## ADDENDUM #2

Date: 07/01/2024

Project: Reroofing Project for the  
Merrillville Community School Corporation  
6701 Delaware Street  
Merrillville, Indiana 46410  
Architect's Project # 24013

SHEET  
**A**  
3.3.0

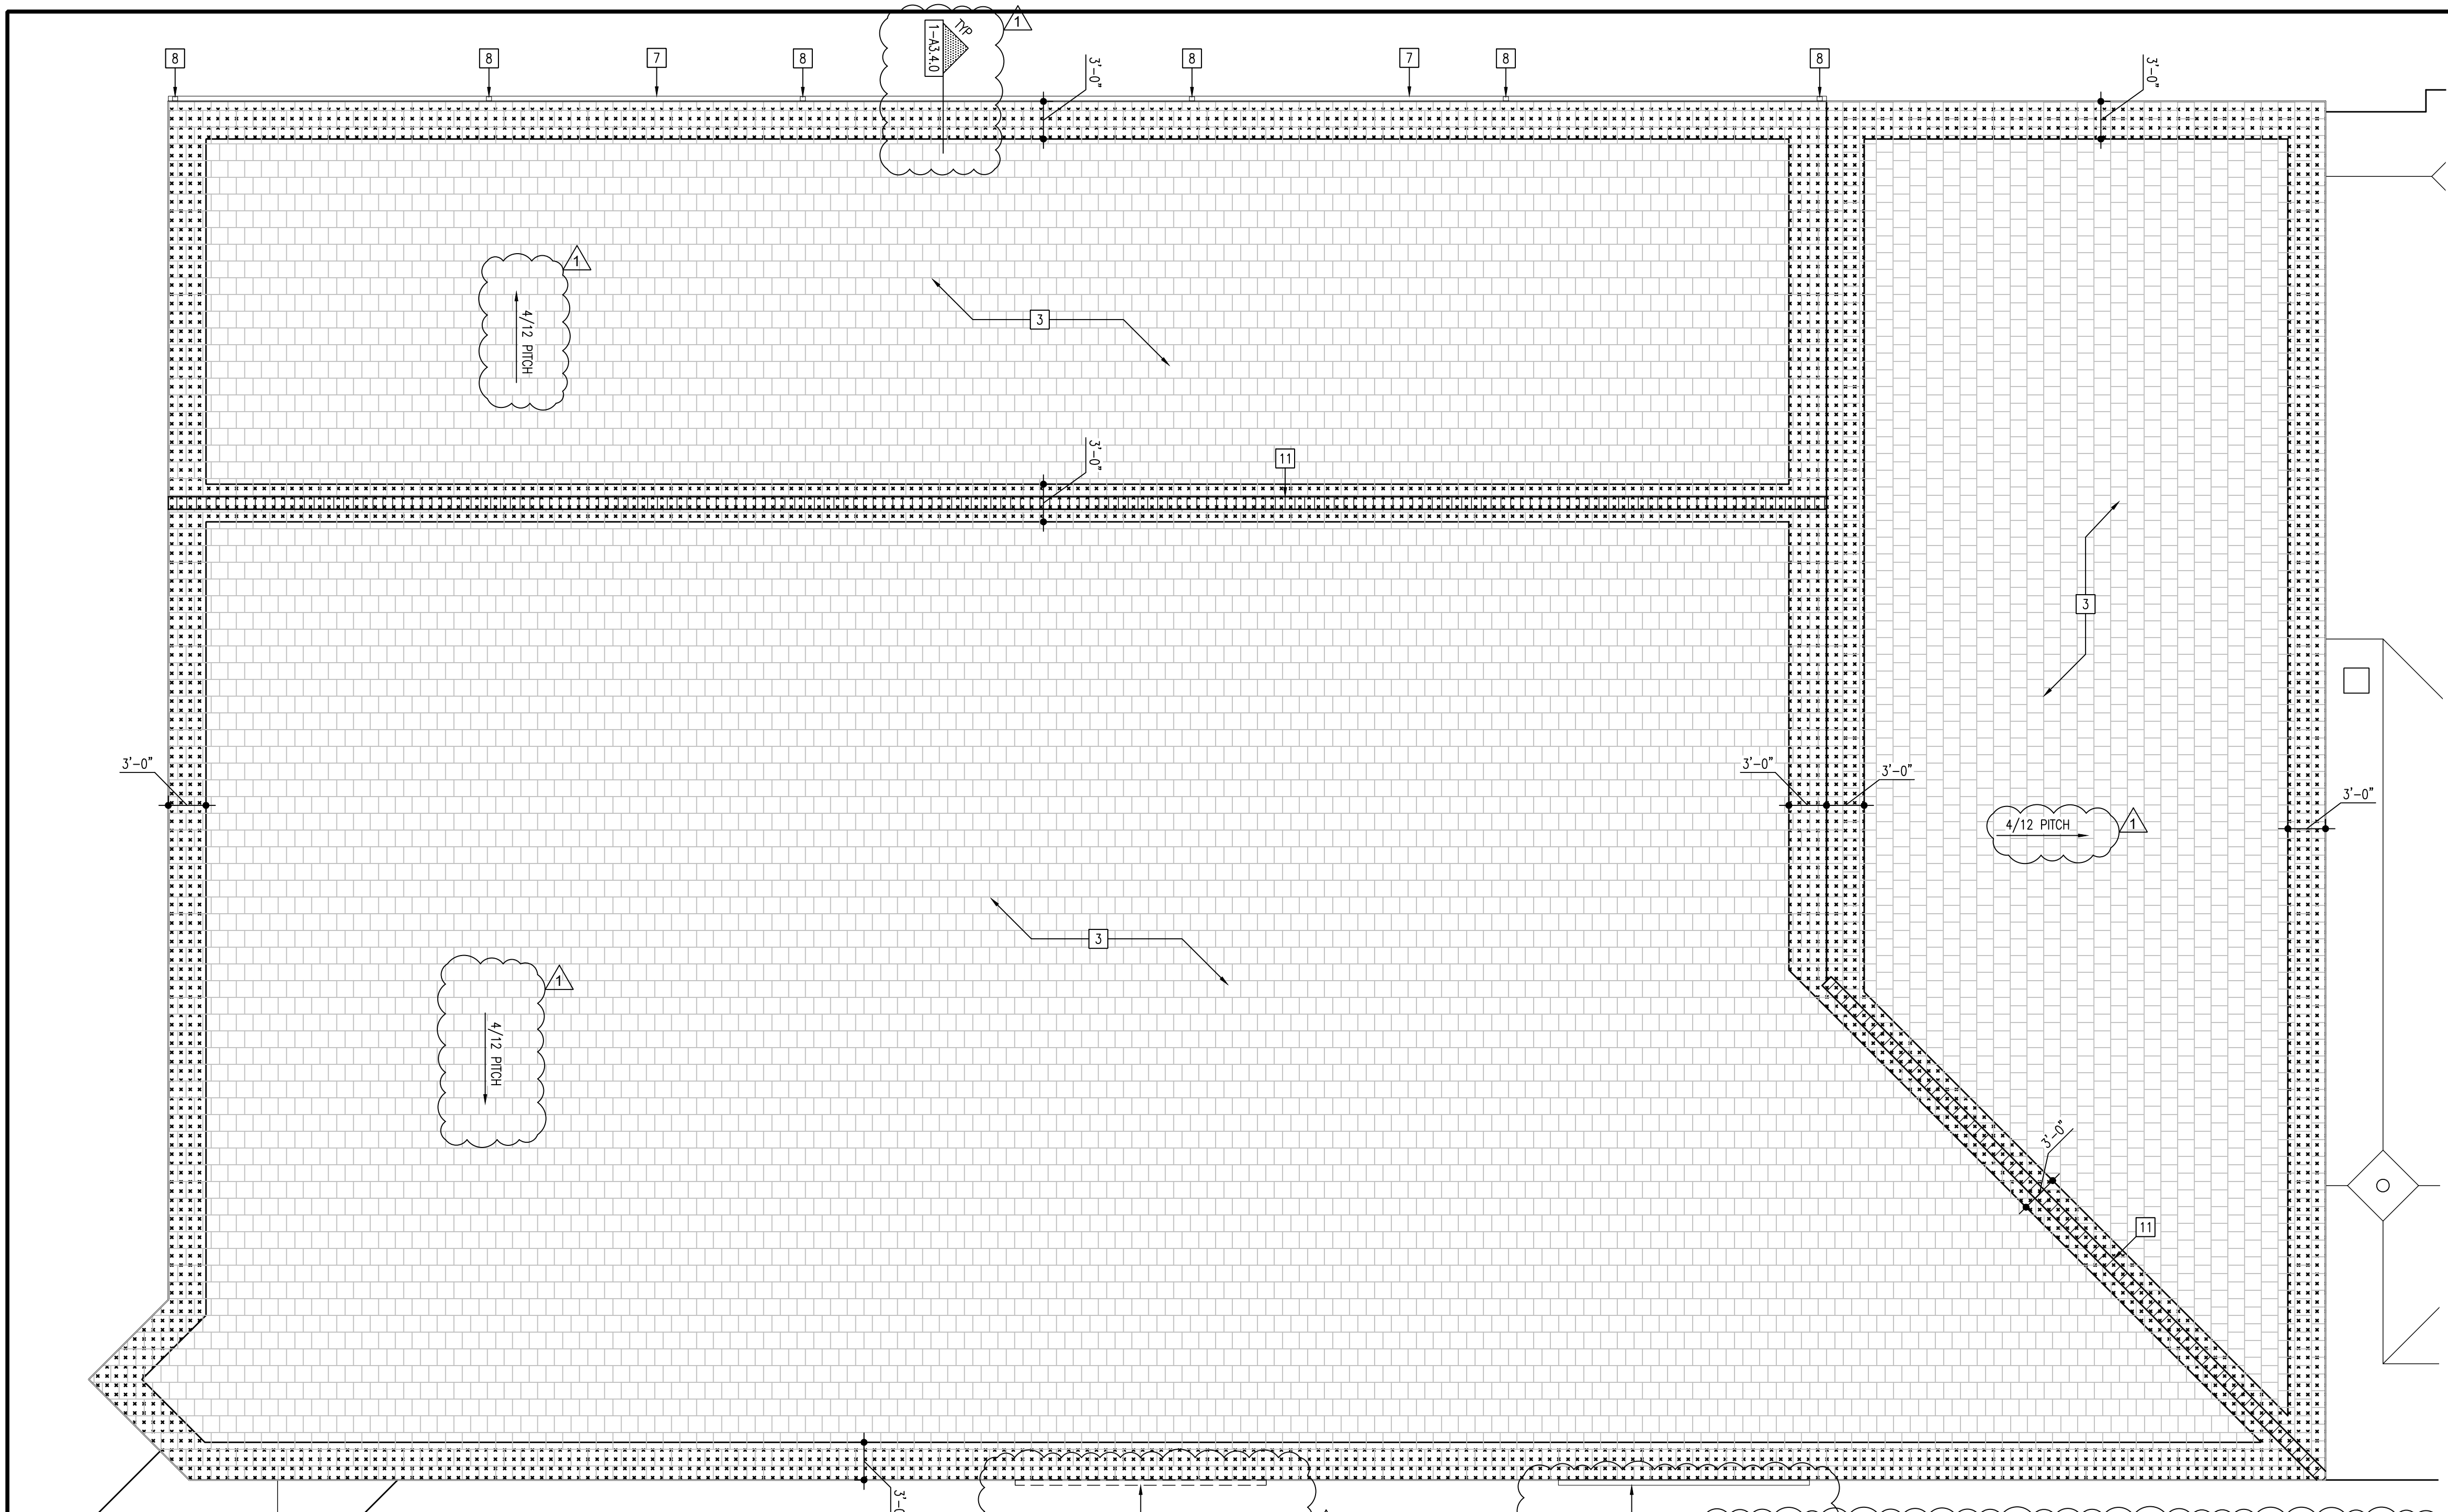
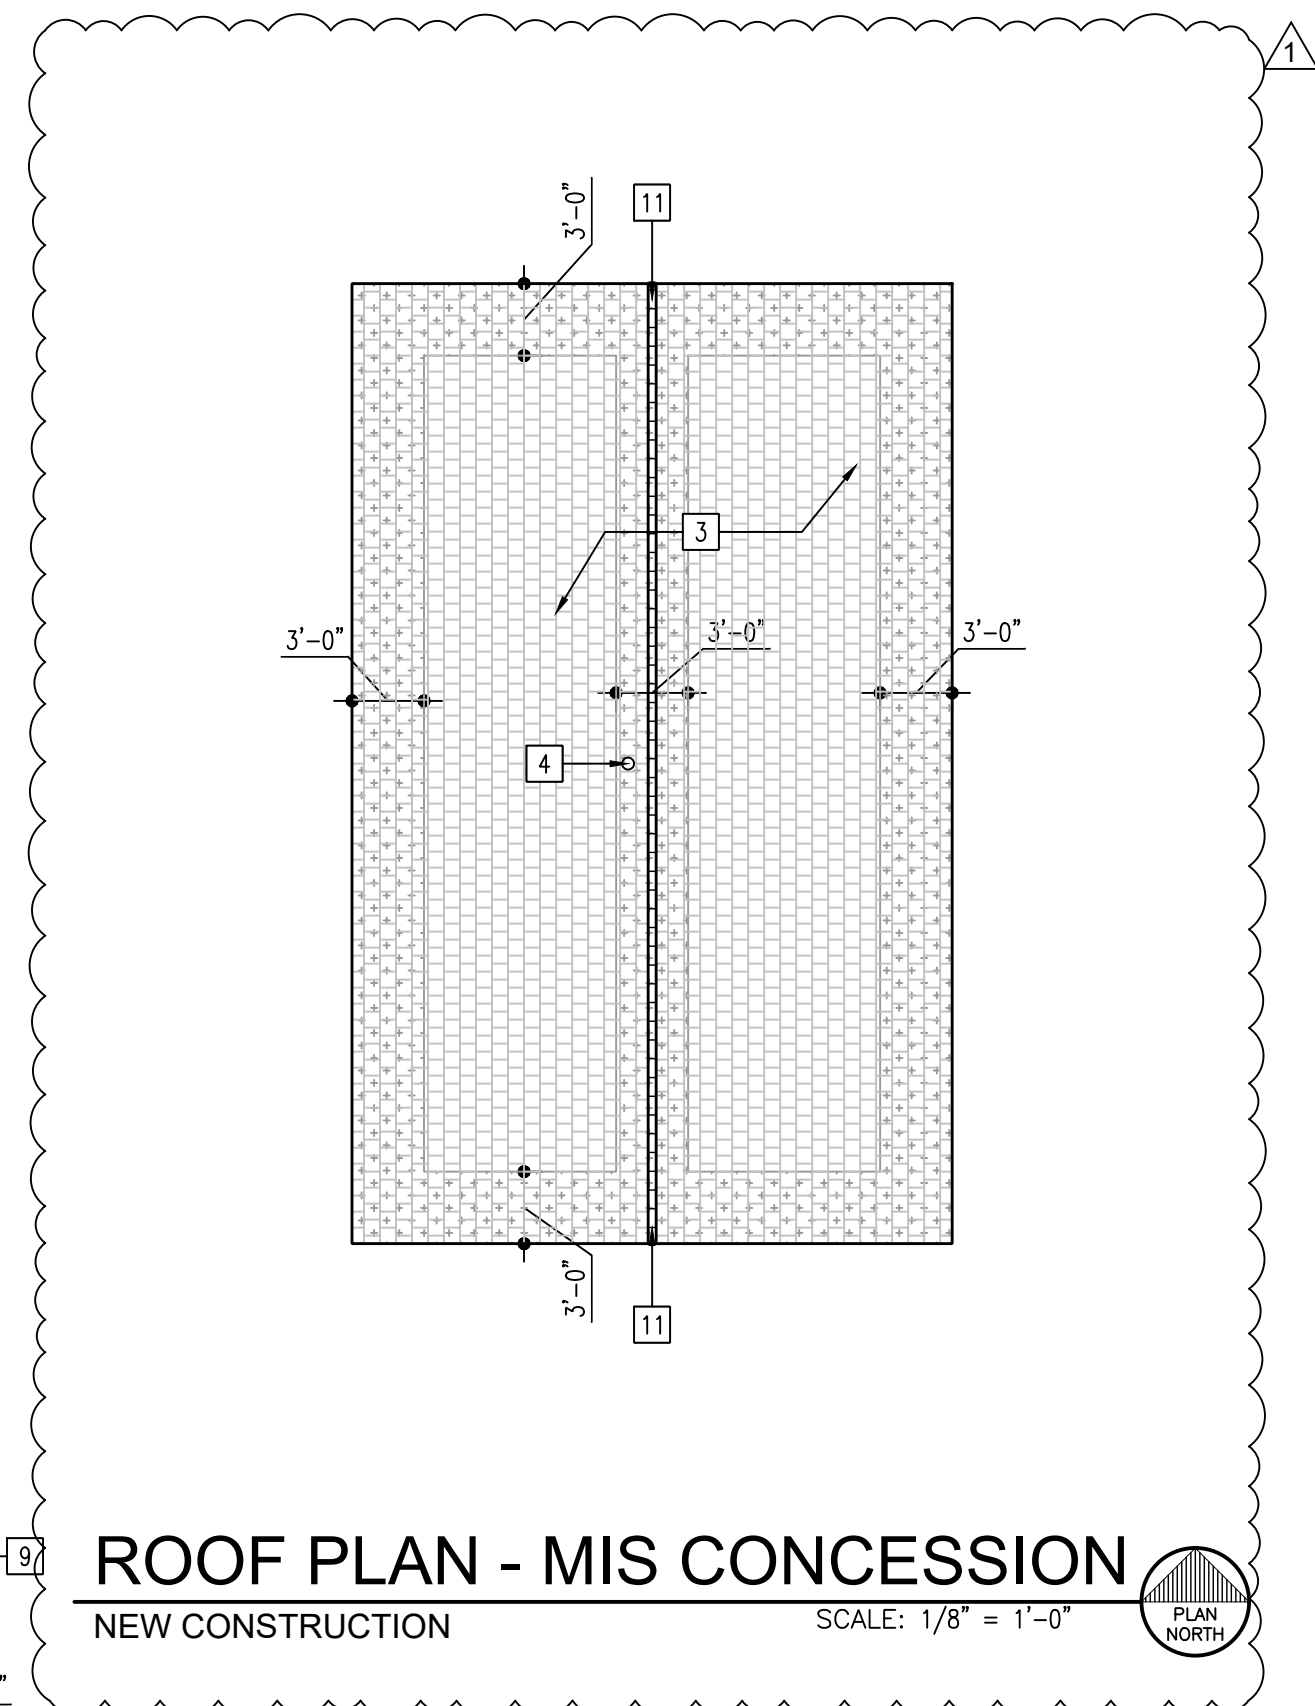
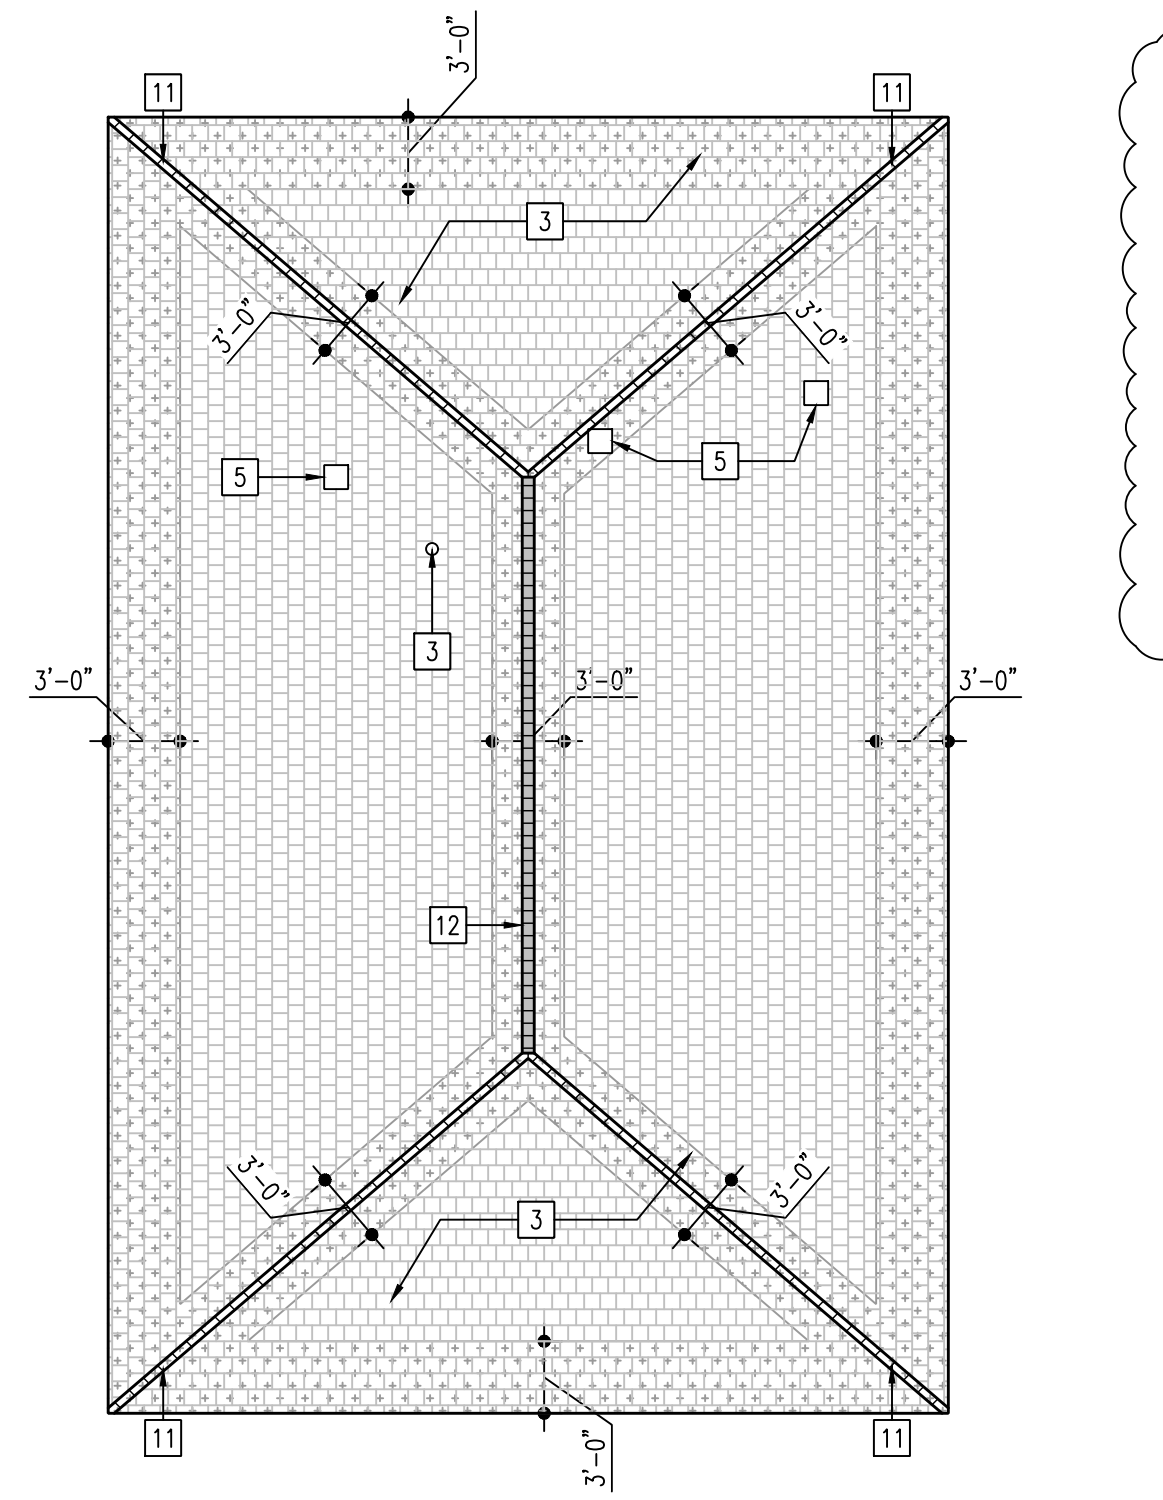
9. See attached Revised Drawing Sheet A3.3.0 – Roof Plan Pierce Middle School & Pierce & MIS Concession – This plan shows clouded and tagged revisions dated 07/01/2024.
